KE2401_CONFY
RFI no.11_Response
16.10.2026

This brochure is prepared in response to the Further Information (FI) Request issued by Kildare County Council (KCC) on the 27th of August 2026 (Reg. Ref.: 26/60746) in respect of a proposed Large-scale Residential Development (LRD) on lands within the townlands of Newtown and Confey, Leixlip, Co. Kildare. Specifically it addresses the landscape items.

Confey Phase 1a LRD

PLAY-MAP EXTRACT, DETAILED BY KOMPAN AT PLANNING STAGE

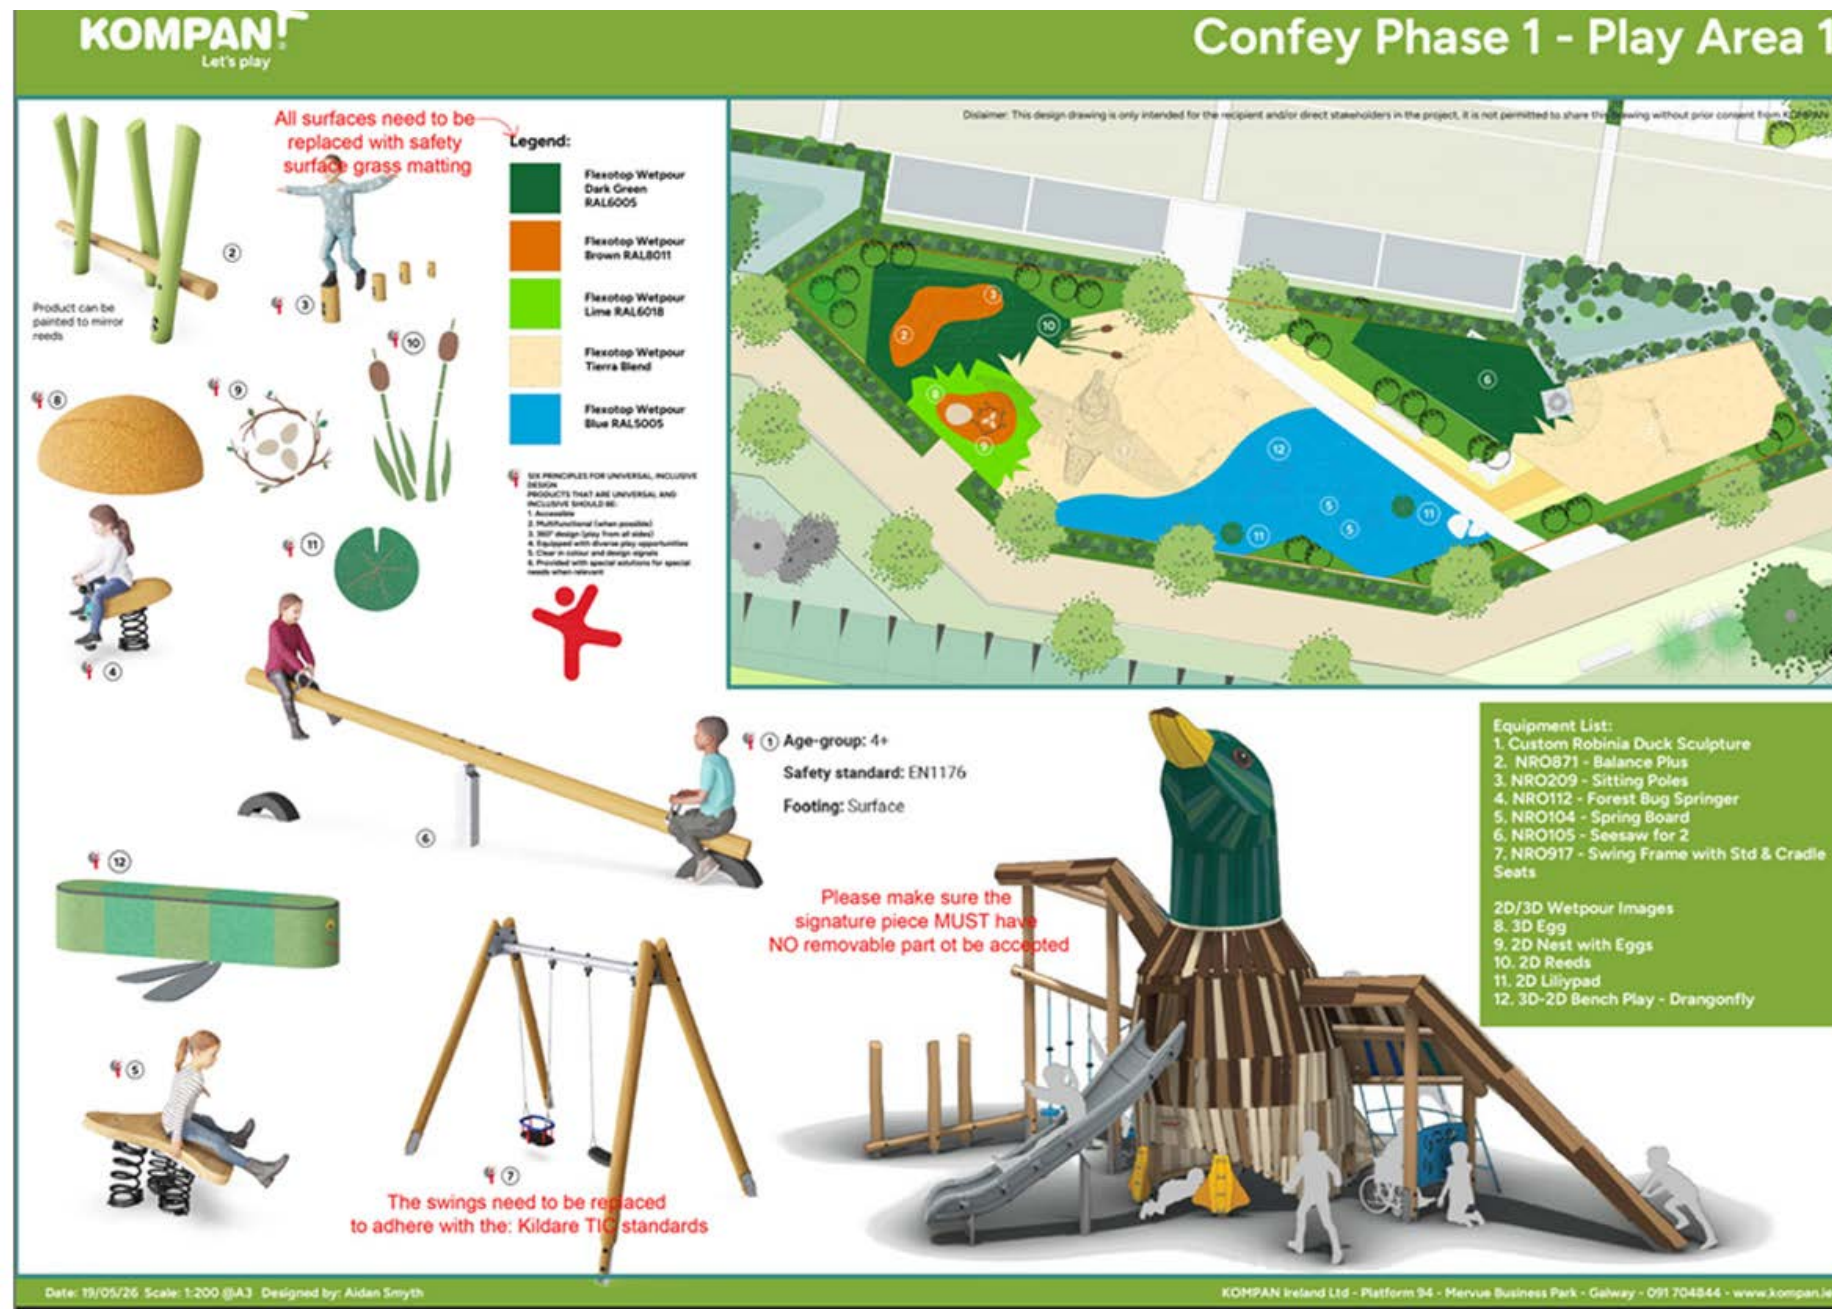
- (a) The Applicant is requested to revise the Taking in Charge arrangements for the play areas (PG1) within the linear park, which are currently indicated to be managed by an Owners' Management Company (OMC). These play areas should instead be designed and constructed to facilitate taking in charge by the local authority.
 - (b) The proposed play equipment incorporating movable parts should be removed and replaced with equipment comprising non-movable elements only.
 - (c) The bespoke play equipment should be revised or removed and replaced with an alternative play solution acceptable to the local authority.
 - (d) All safety surfacing within the play areas shall be revised to provide safety grass matting only. No loose-fill or wet-pour rubber surfacing shall be permitted.
- The Applicant is requested to submit revised details to address the above.

- All surfaces need to revert to grass matts
- All movable parts need to be substituted with non movable play equipment
- Bespoke item: Remove any movable parts

In response to FI Item no. 11, the PG1 play area located within the linear park have been amended, with input from the playground certifier. In summary the play area has been revised as requested to meet the TIC requirements [expand].

SAFAGRASS MATTING: Surfacing has been changed to Safagrass matting under all standard equipment. The coverage is based on high wear areas only as the full safety zones do not need to be covered.

NOTE: It is considered the revised play equipment demonstrates how PG1 can meet the TIC requirements. However, BSLA will continue to work with Kompan to develop a signature piece specifically designed for this play area (which would replace the Tall Multideck Tower) while ensuring compliance with TIC standards. Any revised play equipment would be agreed with KCC Parks prior to any works and the details could be secured by way of condition.
